PLANNING NOTICE

APPLICANT:	Nova Land Consulting - PA\26\0023
PROPERTY ADDRESS:	17 South Street CARRICK (CT: 146198/1)
DEVELOPMENT:	Subdivision (1 lot to 2 lots), Demolition of 2 buildings & New Residential outbuilding (garage) - attenuation area, lot design, not connected to stormwater.

**RE: Response to Request for Information - PA\26\0023 -Subdivision - 17 South Street,
Carrick**

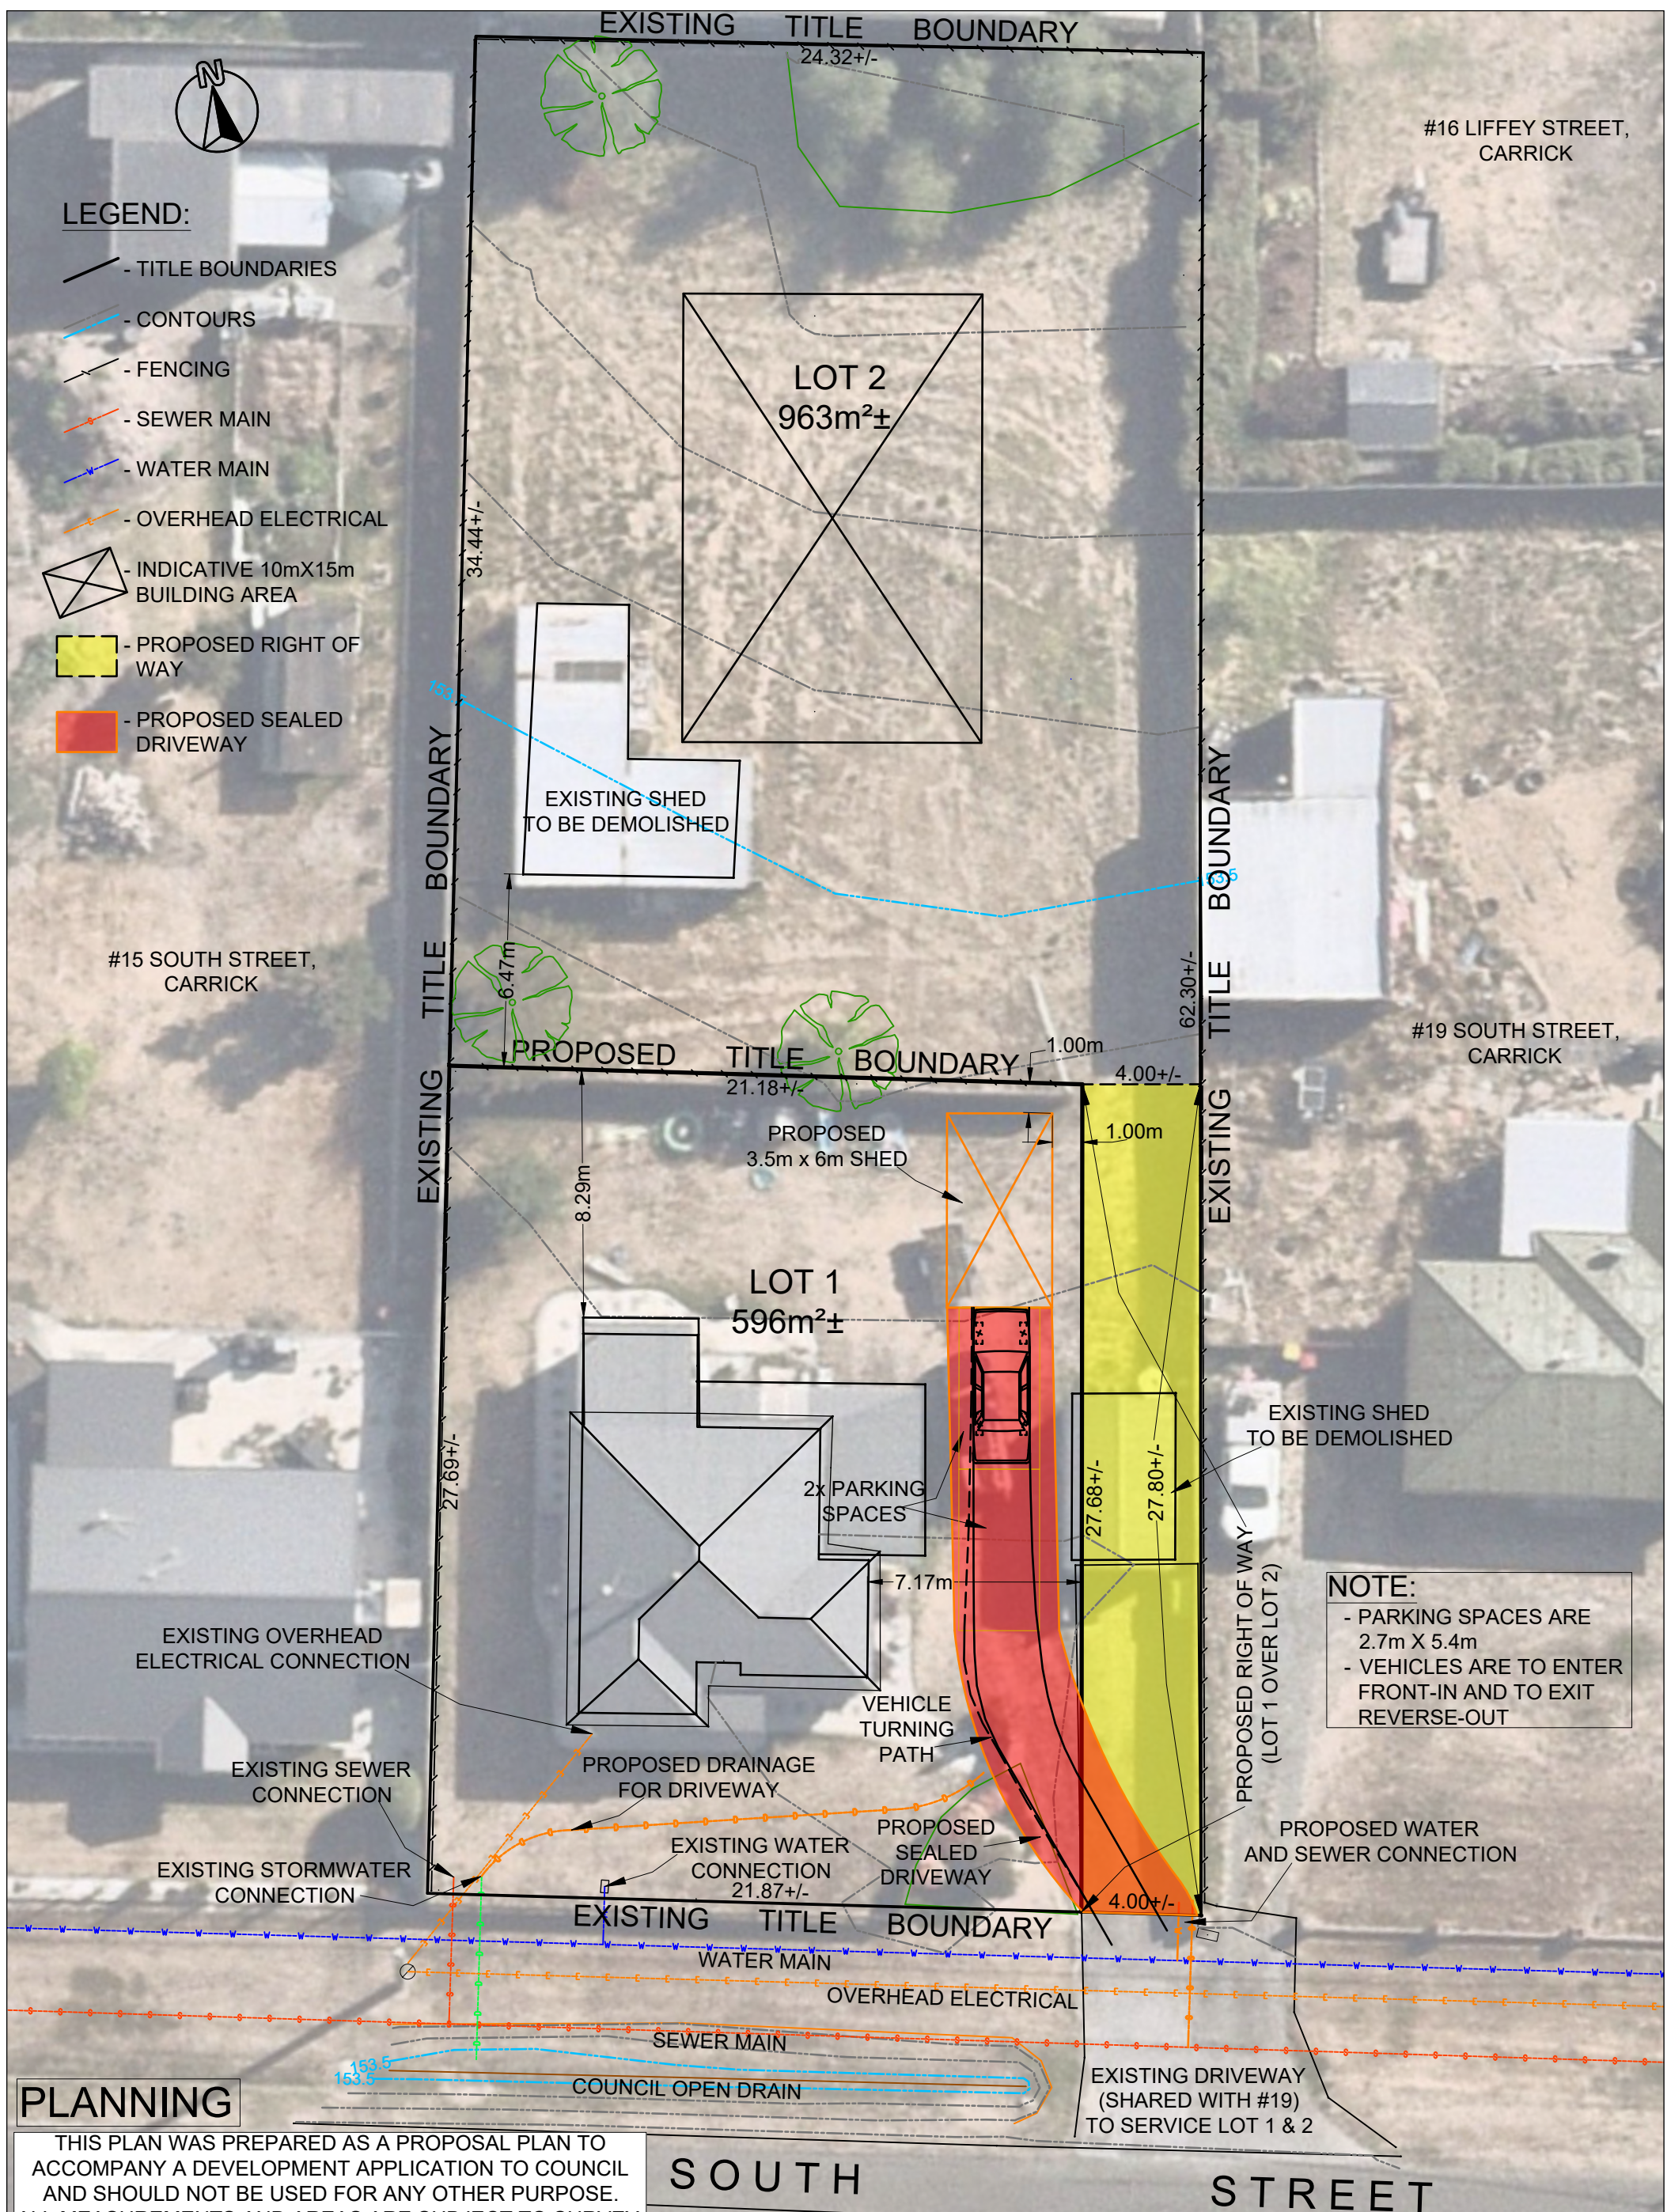
Please find below our response to the matters raised in Council's Request for Further Information on 04 August 2025:

An updated subdivision plan is attached showing the access handle width.

An updated subdivision plan is attached showing the proposed Right-of-Way (ROW), which is to be located entirely within the access handle of Lot 2, providing benefit to Lot 1 but not extending into it.

The updated subdivision plan now shows the full extent of the sealed driveway for Lot 1, including the Right-of-Way, with an indicative alignment and drainage shown as directed to the existing stormwater connection.
